ASC Competition Commercial, Region VII		REQUEST FOR INFORMATION FOR  Emeryville MOB		R.F.I. NO:
  <b>HENSEL PHELPS</b> Plan. Build. Manage.				ISSUING SCHOOL:
		SHEETS:	DETAILS / SECTIONS:	SPECIFICATIONS REF:
TITLE OR SECTION OF WORK:  Stainless Steel Doors and Frames in SPD				
PERTENENT PROBLEM SECTION:  Change Management			ISSUED BY:  DATE:	
WRITTEN DESCRIPTION OF PROBLEM - ATTACH SKETCHES AS REQUIRED:  REF: A2.02, A10.51, Performance Requirements C1020  Openings 2316, 2316A, 2316C, 2317E, 2317FA and 2317FB located in Processing 2317 are shown to receive Wood Doors and 16 Ga HM frames per the door schedule sheet A10.51. Doors 2317 and 2317F, alos located in Processing 2317 are shown to have Wood Doors and standard aluminum frames.  Please confirm the doors and frames listed in SK-01 are to be Stainless Steel in compliance with the design guidelines attached.				
A/E RESPONSE:				
BY: DATE:

**EMERYSTATION MOB RETROFIT  
EMERYVILLE, CA**

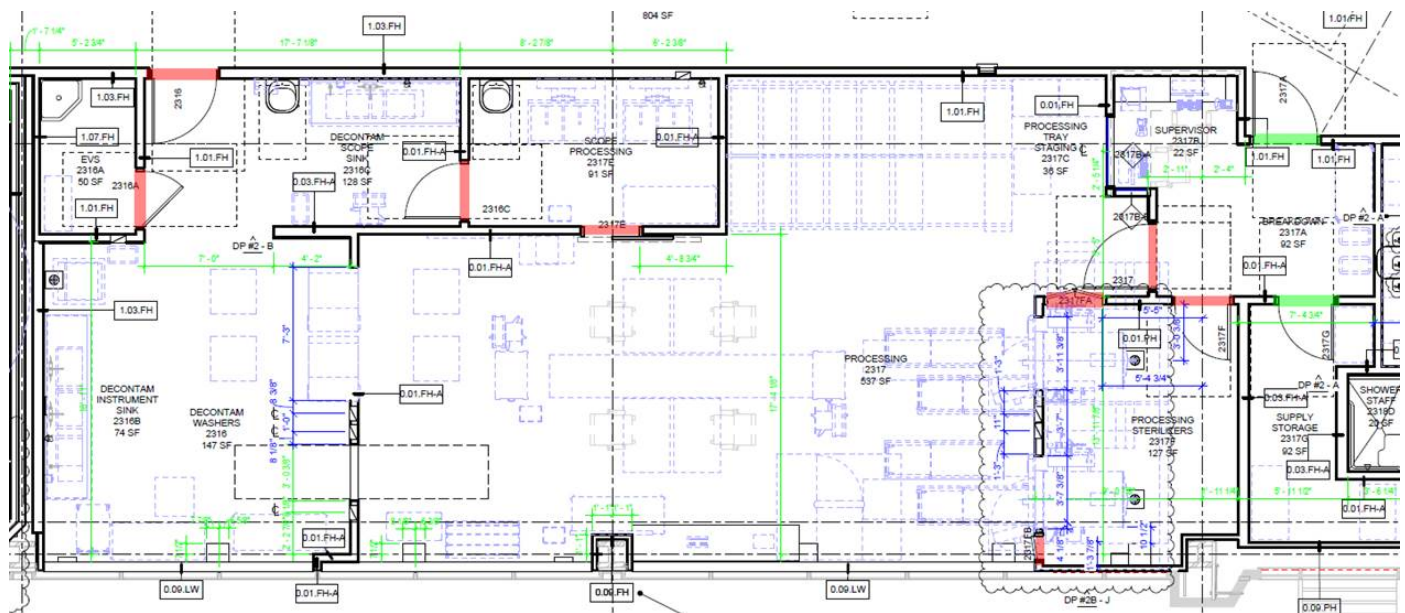
Doors and Frames to be SS

- 2313A
- 2316
- 2316A
- 2316C
- 2317
- 2317E
- 2317F
- 2317FA
- 2317FB

Owner Performance Requirements require Stainless steel doors and frames. Specs and door schedule sheets call for HMF and Aluminum Knock down with wood doors
